TIER 1 SEISMIC EVALUATION
Immediate Occupancy Structural Performance Level
Campbell City Hall
Campbell, California

Draft Report

Prepared For:
City of Campbell
70 North First Street
Campbell, California

Prepared By:
Biggs Cardosa Associates, Inc.
101 California Street, Suite 875
San Francisco, California

SECOND FLOOR PLAN

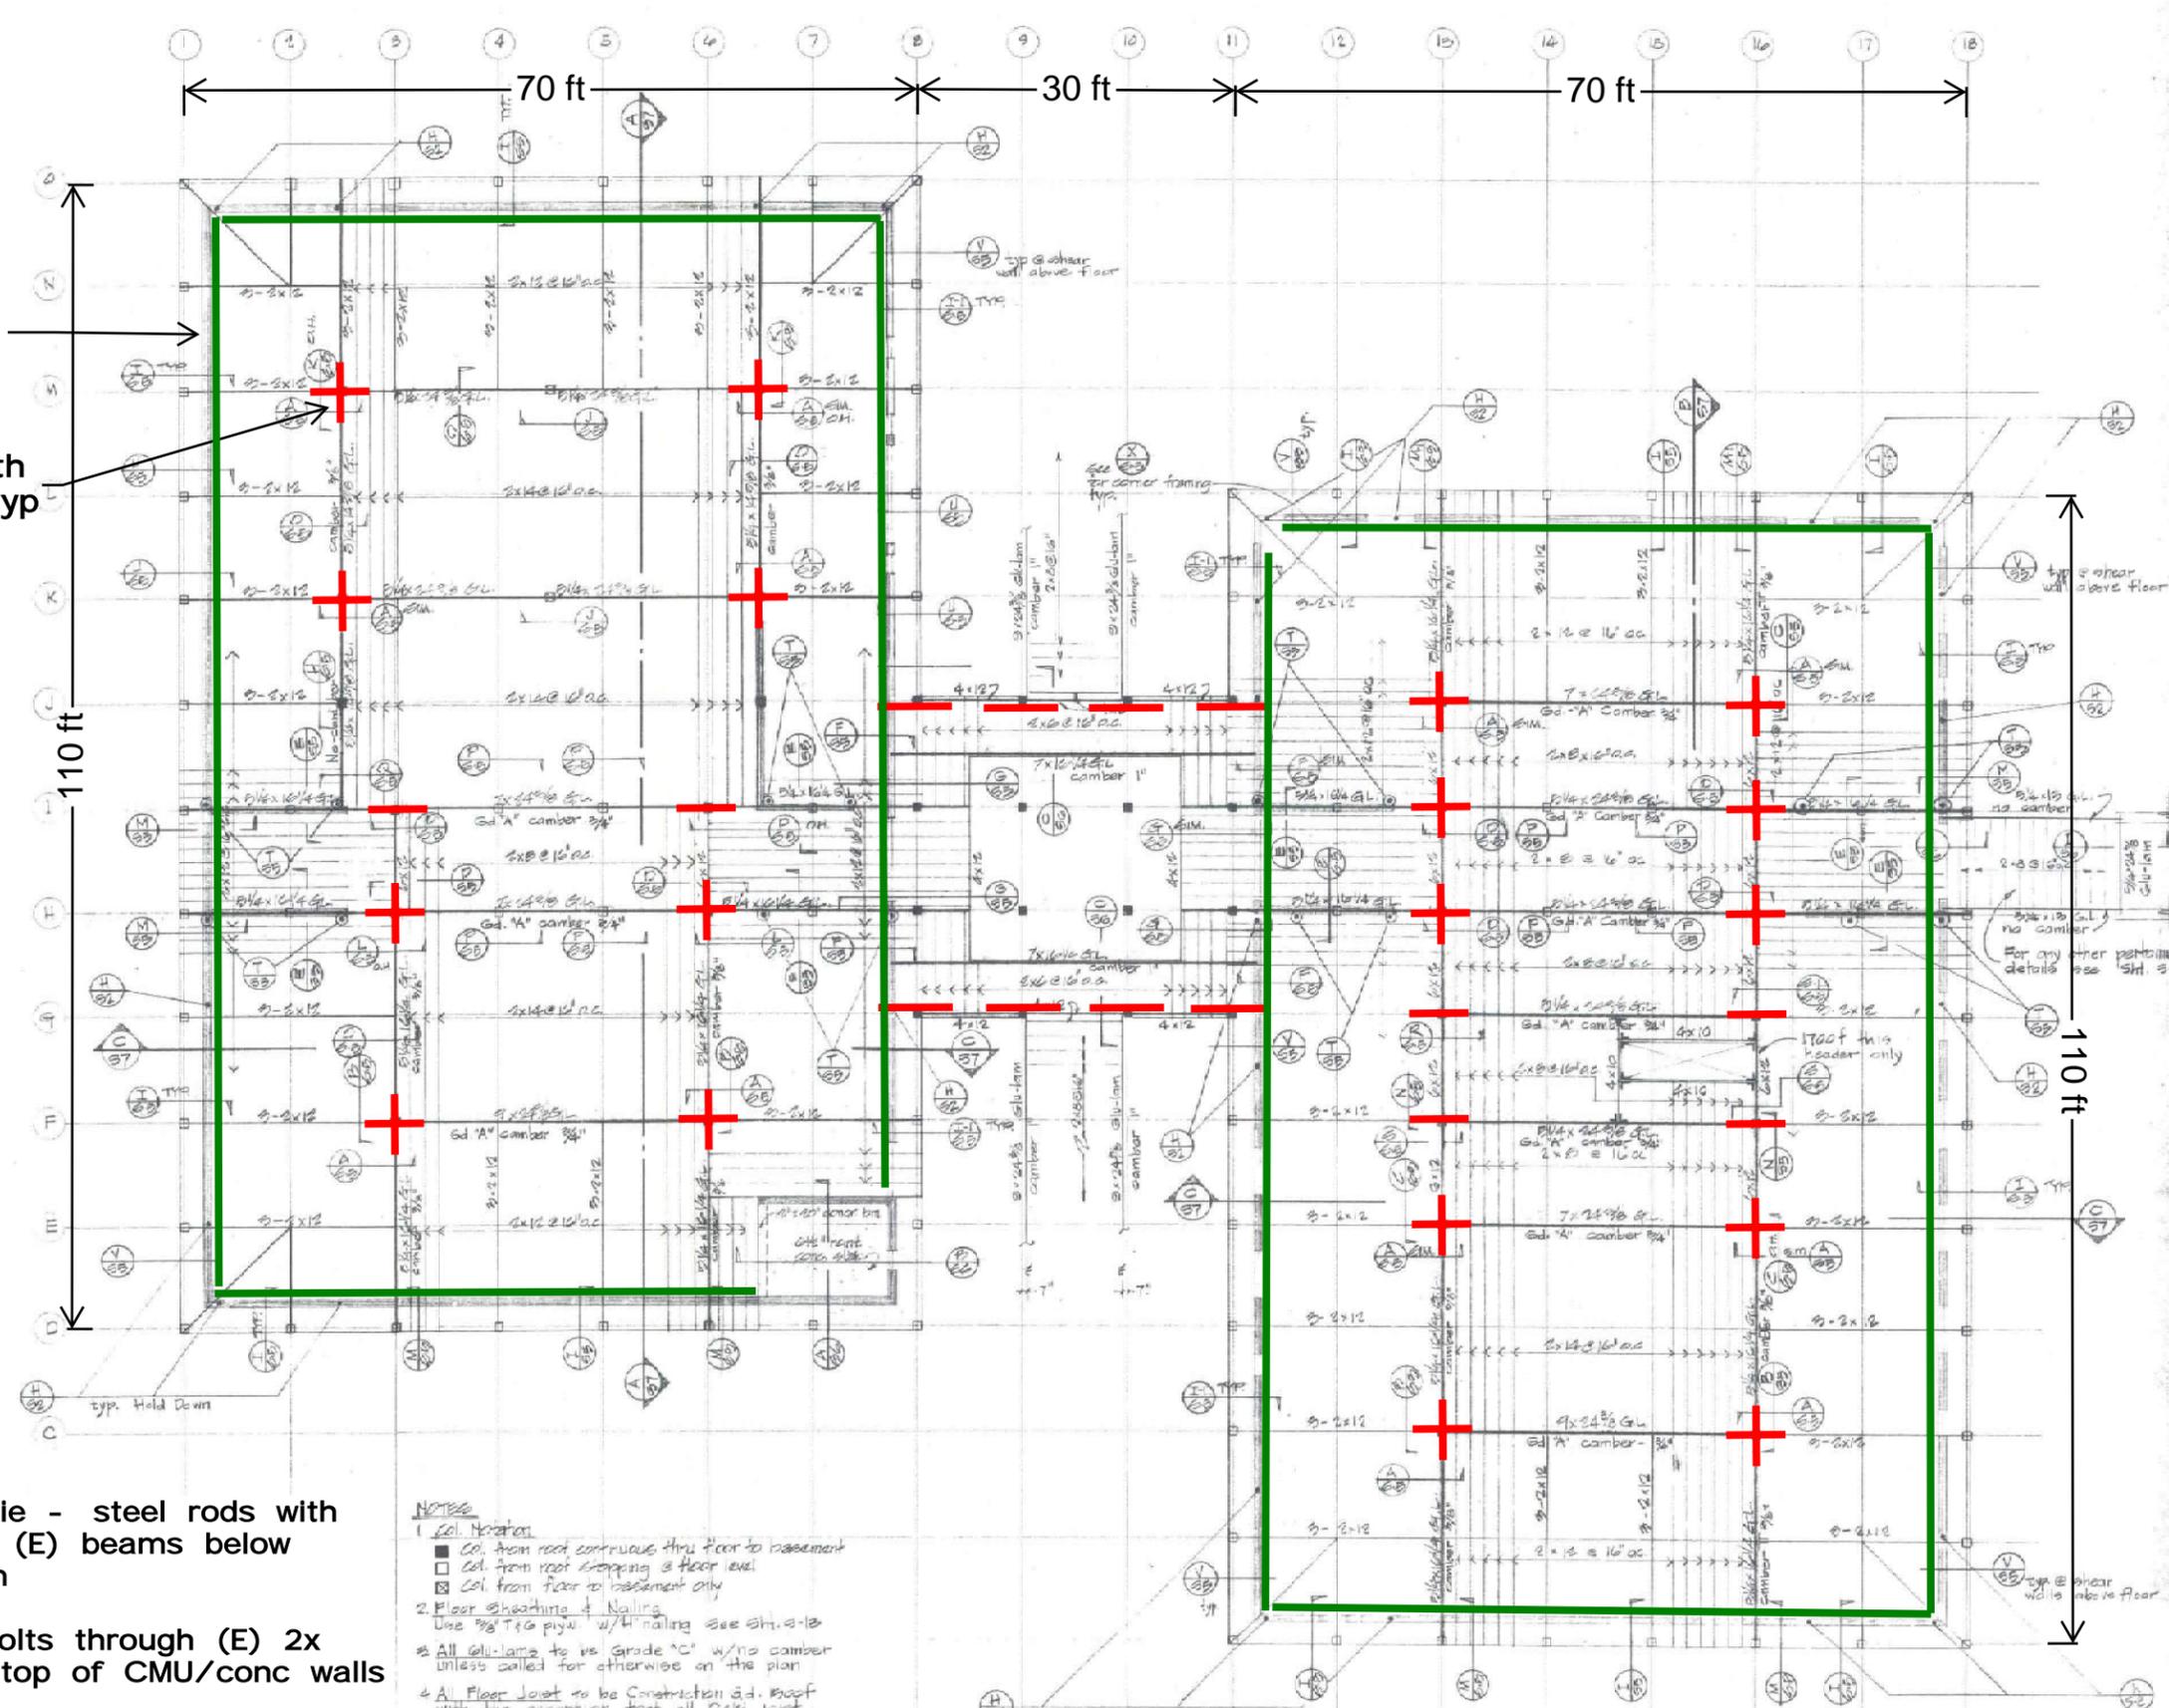
1. At low roof level, collectors along shear wall lines are inadequate for transferring the diaphragm load to the shear walls. Addition of new steel straps with blocking between joists is required.
2. At second floor level, building cross-ties are inadequate for transferring out-of-plane masonry wall loads into the floor diaphragm. Addition of new horizontal steel straps or steel rods with holdowns is required at beam splice locations (typically at columns).

3. At the second floor level, the wood shear walls are inadequate to transfer in-plane seismic loads. Addition of new plywood at the existing shear walls along with steel straps, and steel rods with holdowns is required.
4. At the second floor level, the masonry wall-to-floor connections appear to be inadequate for both in-plane and out-of-plane wall loads. The addition of new anchor bolts will be required.
5. At the high roof level the steel cantilever columns are inadequate for transferring seismic loads into the main roof diaphragm. New infill stud walls with plywood sheathing are required.

1. At low roof level, provide new collectors along shear wall lines by adding new steel straps over plywood sheathing, with new blocking between the joists. [See Deficiency 1 above].
2. At second floor level, provide building cross-ties by adding new horizontal steel straps or steel rods with holdowns at beam splice locations (typically at columns). [See Deficiency 2 above].
3. At second floor level, provide new plywood at several existing shear walls along with new steel straps and steel rods with holdowns. [See Deficiency 3 above].
4. At the second floor level, provide new anchors bolts drilled through the existing wood sill plate and epoxied into the top of the existing masonry walls. [See Deficiency 4 above].
5. At the high roof level, provide several new infill wood stud walls with new plywood sheathing at the clearstory between the low roof diaphragm and high roof diaphragm.

- Indicates (N) seismic tie - steel rods with holdowns each side of (E) beams below second floor diaphragm
- Indicates (N) anchor bolts through (E) 2x wood sill epoxied into top of CMU/conc walls at 4'-0" on center

HIGH ROOF PLAN

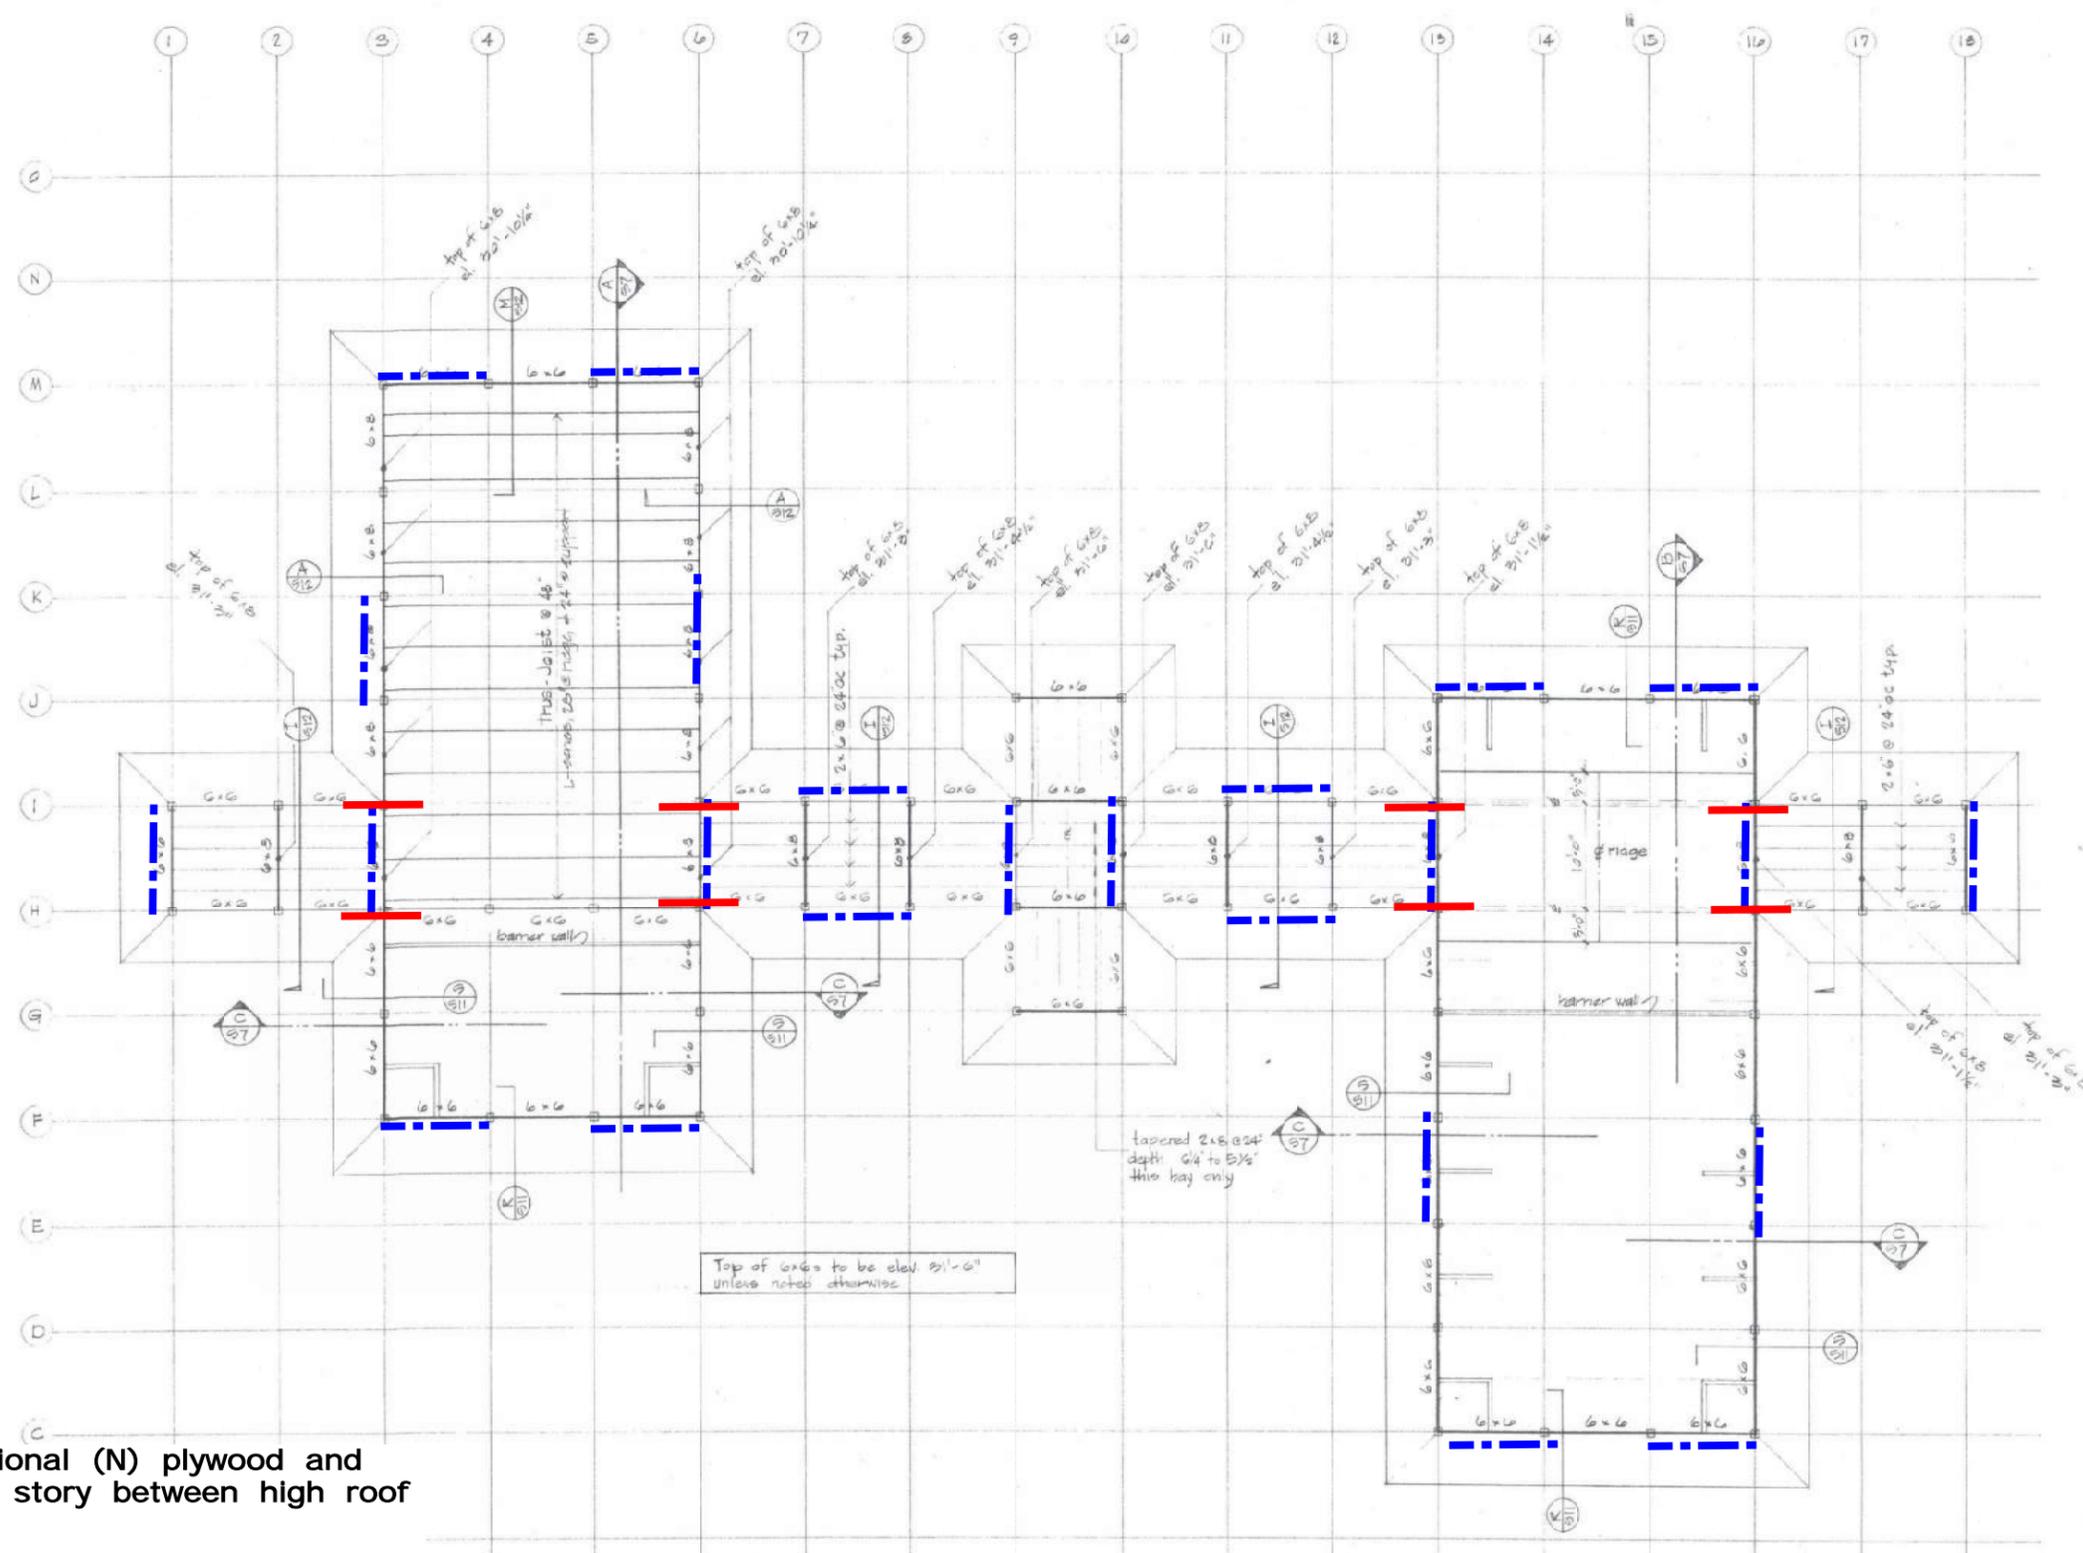
The shear capacities of the roof and second floor plywood diaphragms appear to be adequate for transferring the seismic forces to the shear walls; the details and capacities of the roof diaphragm chords/collectors, however, need strengthening. The steel cantilever columns supporting the high roof appear to be inadequate for transferring the seismic forces into the main roof diaphragm. New lateral elements will need to be added in the clearstory between the high roof and low roof.

--- Indicates additional (N) plywood and studs at clear story between high roof and low roof

— Indicates (N) seismic tie - steel rods with holdowns each side of (E) beams below high roof
